BWIP REVIEW COMMENT RECORD (RCR)

5. Document Number
WM DOCKET CONTROL CENTER
Expedited Special Case package; documents for re-start of PDR 24CX and DC-25CX.

Document Number(s)/Title(s)
Response to:
Proposed Restart of Drilling of
DC-23, DC-24, DC-25, DC-32 and
DC-33 for BWIP Hydrology Program

FIGURE 2

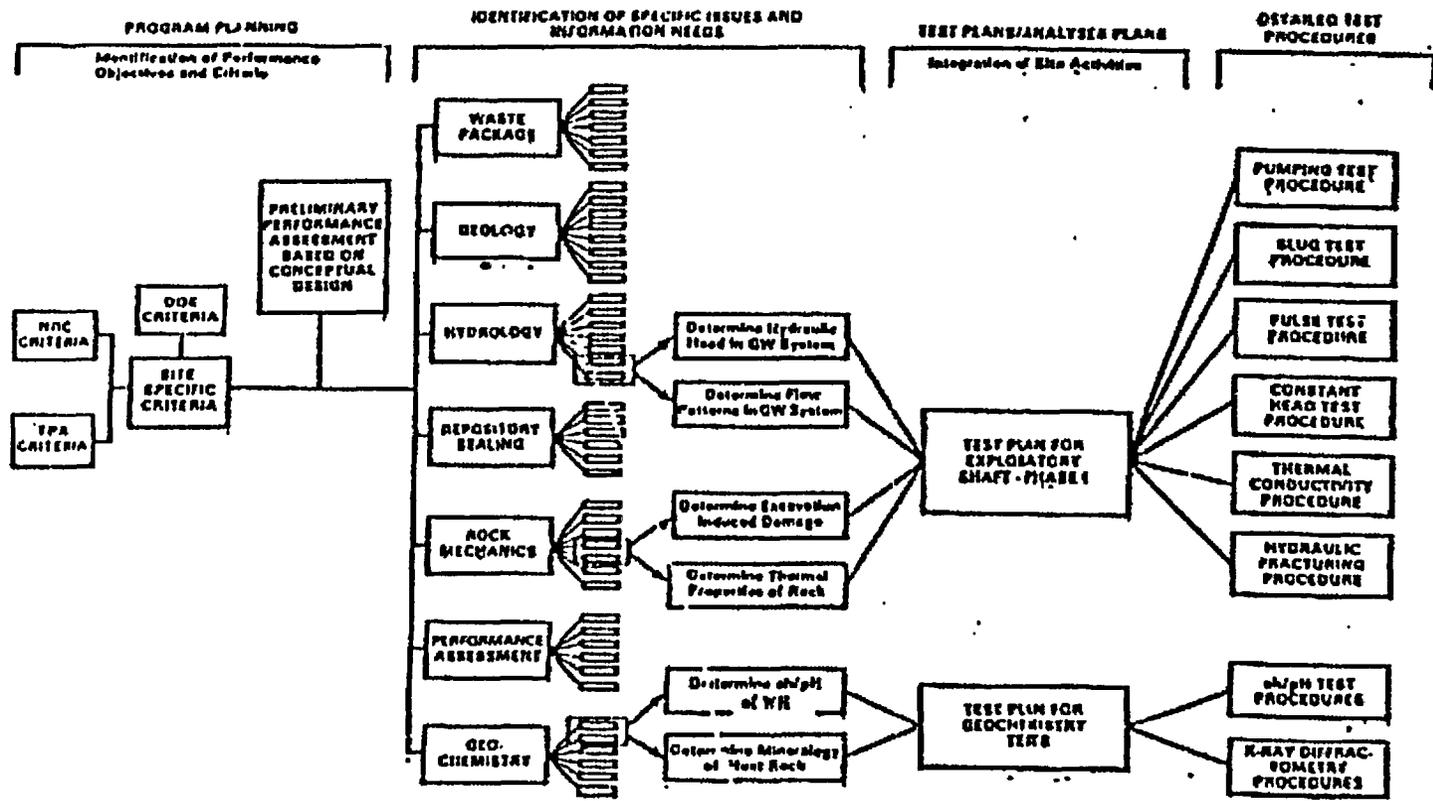
5. It would appear that DOE/DWIP has put into place sufficient checks and balances through the HQ-1 QA/QC program to insure that licensable date will be obtained. However, there is some concern that the field investigation program is so enveloped in procedures and QA inspections that the professional staff responsible for the geohydrology program will not be able to conduct a sound technical program. Procedures are never a substitute for good professional, experienced judgment.

The Nuclear Regulatory Commission (NRC) requires implementation of the 18 criteria, delineated in Title 10, Chapter 1, Code of Federal Regulations - Energy, Part 50, Appendix B (10 CFR 50, App. B), in the quality assurance (QA) program to be applied during site characterization. The NRC Review Plan, 1984, identifies how the staff will review these QA program descriptions. The NRC Review Plan emphasizes the requirements for QA programs and the interaction of the QA groups including management meetings, audits, inspections, and performance monitoring.

The following excerpt from the NRC Review Plan provides the flavor of the NRC's expectations for documentation of procedures:

"The plans outlining the conduct of a data gathering program are of varying levels of detail ranging from identification of general performance objectives and criteria to detailing specific technical procedures (Figure 2, see attached)."
